**TOWN OF ADDISON  
BUILDING REPORT**

**Facility Information:** **Facility Name:** Town Hall  
**Facility Contact:** Lisa Pyles **Contact Phone:** 972-450-2878

**Accessology Inspector Information:**  
**Inspector:** Karen Jackson **Date:** April 21, 2017  
**Email:** Kjackson@accessology.com

**Latitude:** 32.952568 **Longitude:** -96.81562  
**Address:** 5300 Beltline Road **City:** Addison **County:** Dallas

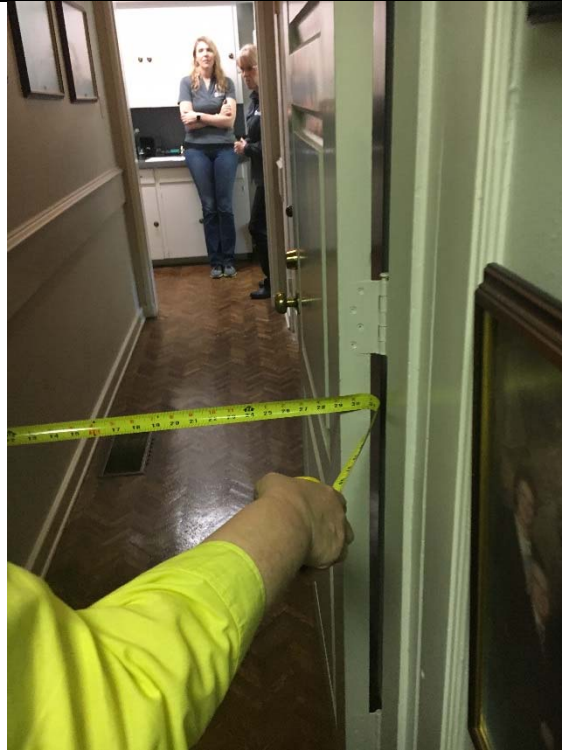
**Violation 15** - The far right back entrance has a threshold that is greater than 1/2".

**Violation 16** - There are approximately 7 doors throughout the facility with door hardware that requires grasping and twisting to operate.

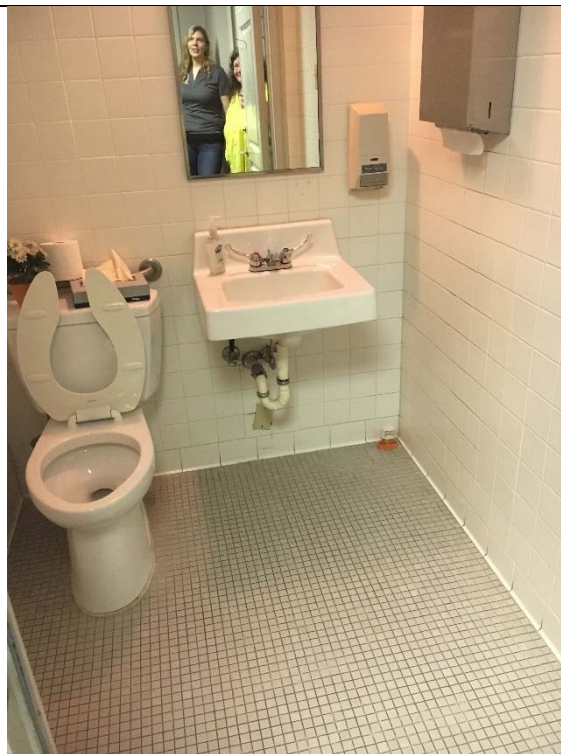
**Violation 31** - Women's Room: Coat hook is mounted at 61-1/2" above finished floor.

**Violation 32** - Women's Room: Cabinet provided over the water closet is an overhead protrusion.

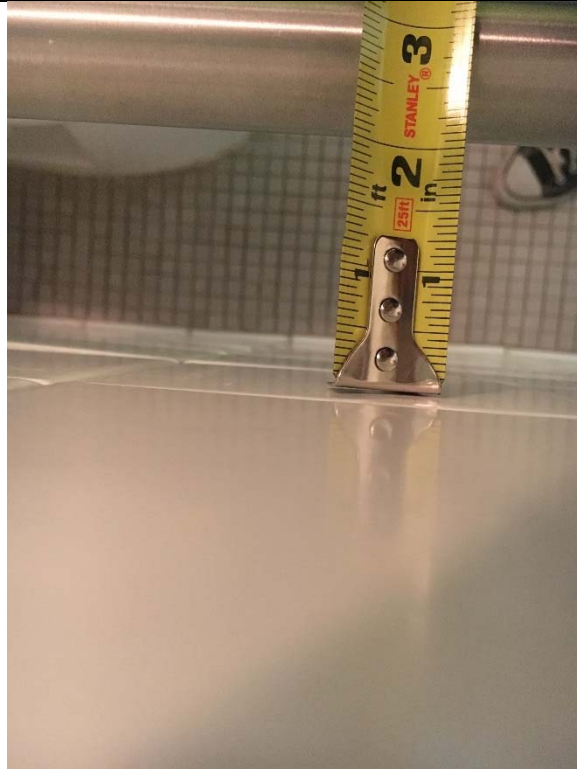
**Violation 38** - Men's Room: The operation portion of the paper towel dispenser is at 50" above finished floor.

**Violation 39** - Men's Room: Mirror is at 44-1/2" to the bottom of the reflective surface.

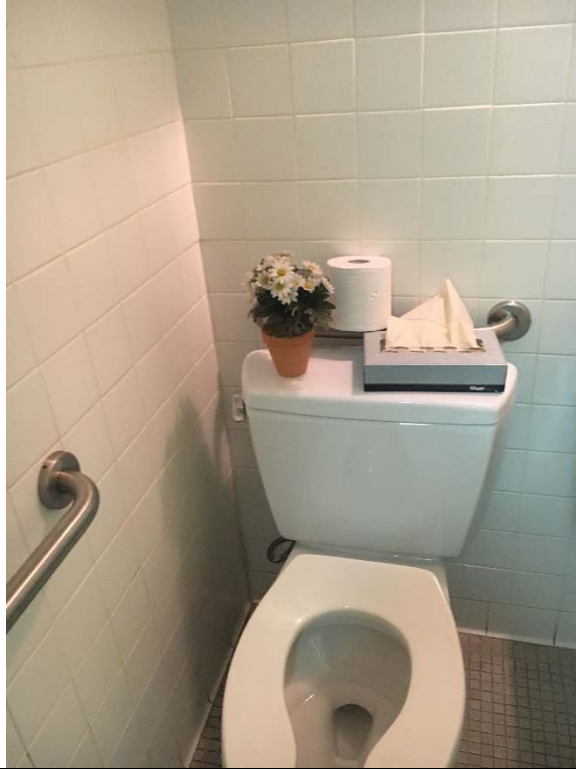
**Violation 40 - Men's Room:** The side grab bar has over a 2" space between the grab bar and the wall. The rear grab bar is only 12" long.

**Violation 41 - Men's Room:** Water closet centerline is at 14-1/2".

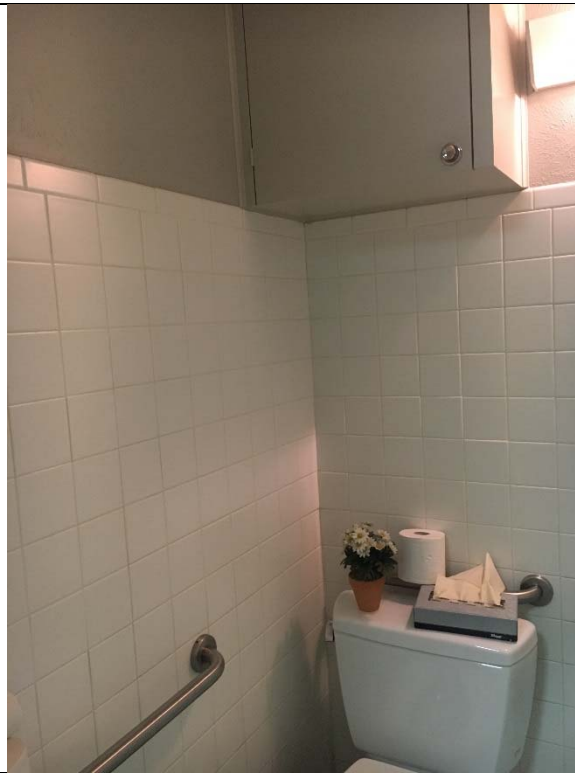
**Violation 42 - Men's Room:** Water closet flush control is on the closed side.

**Violation 43 - Men's Room:** Cabinet provided over the water closet is an overhead protrusion.

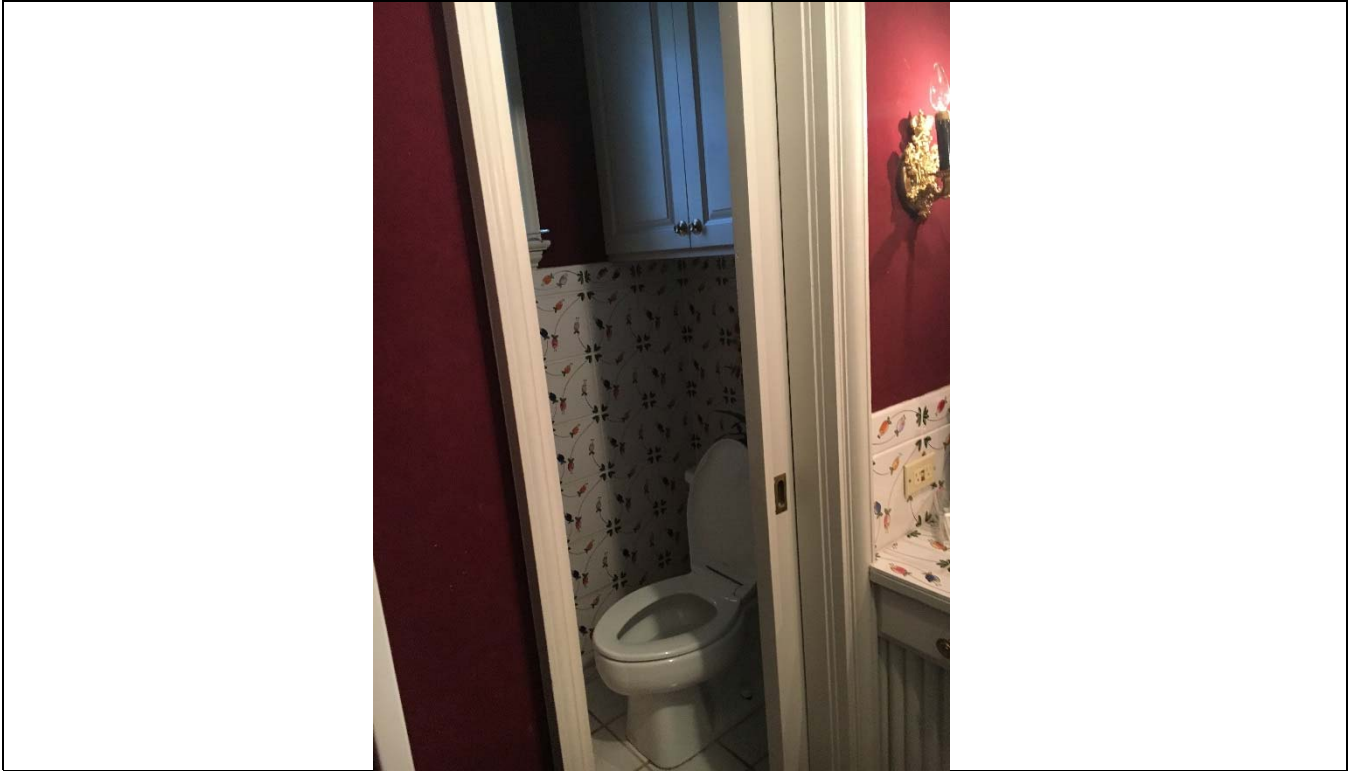
**Violation 44** – The small restroom at the front of the building has no accessible features.

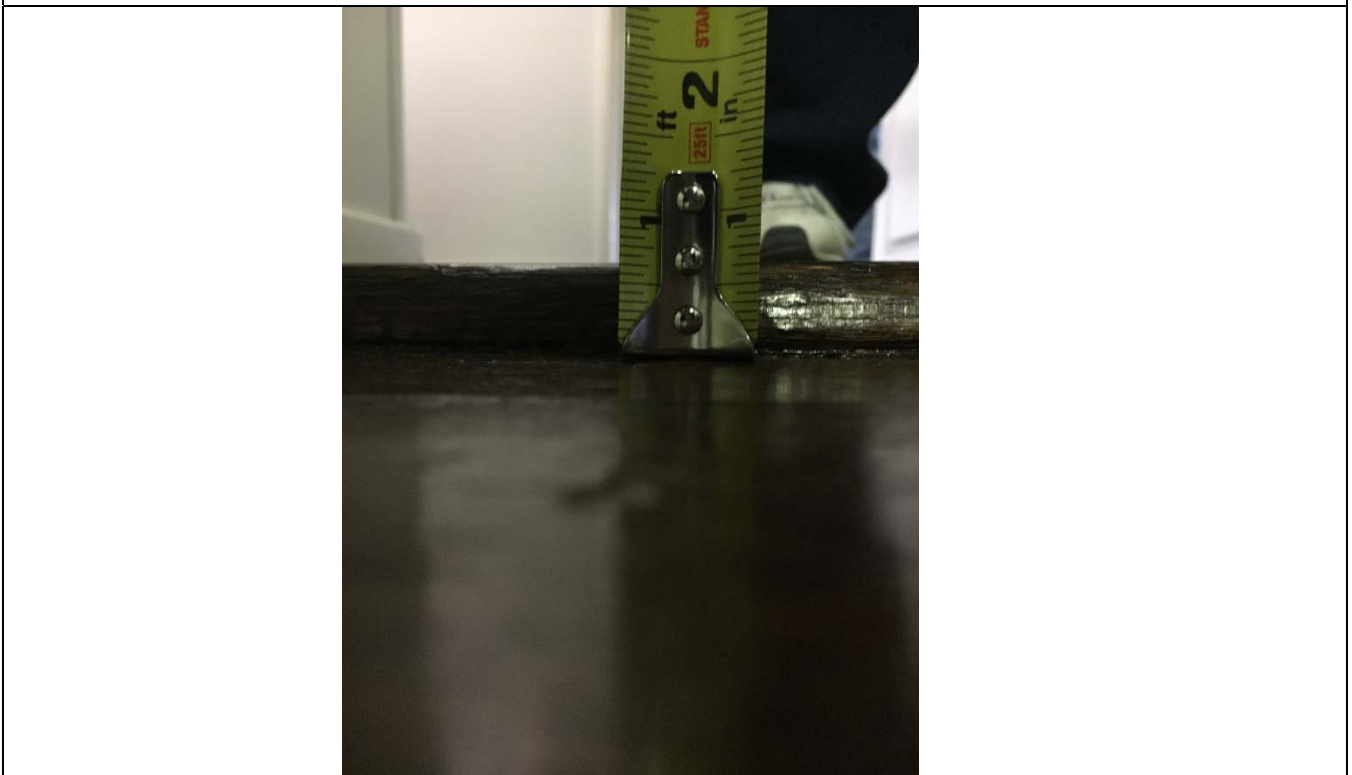
**Violation 45** - There is a 5/8" step to get into the break room.

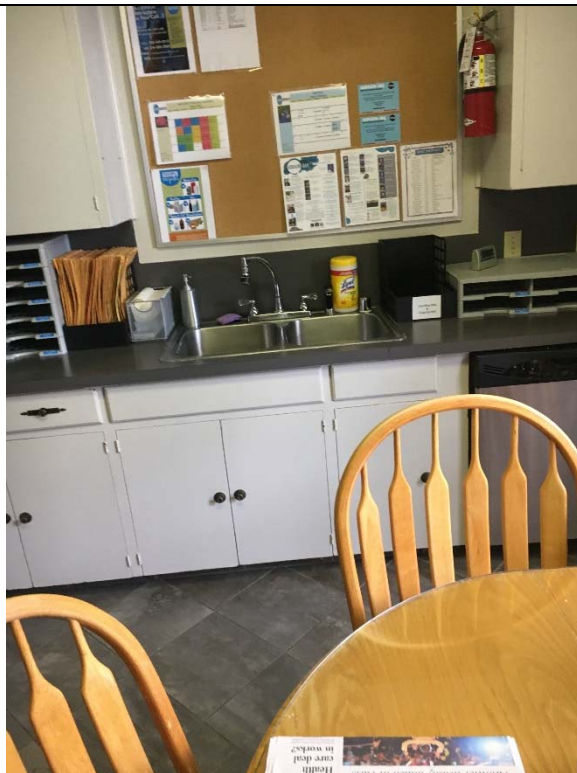
**Violation 46** - The door width leading into the break room is only 29" wide.
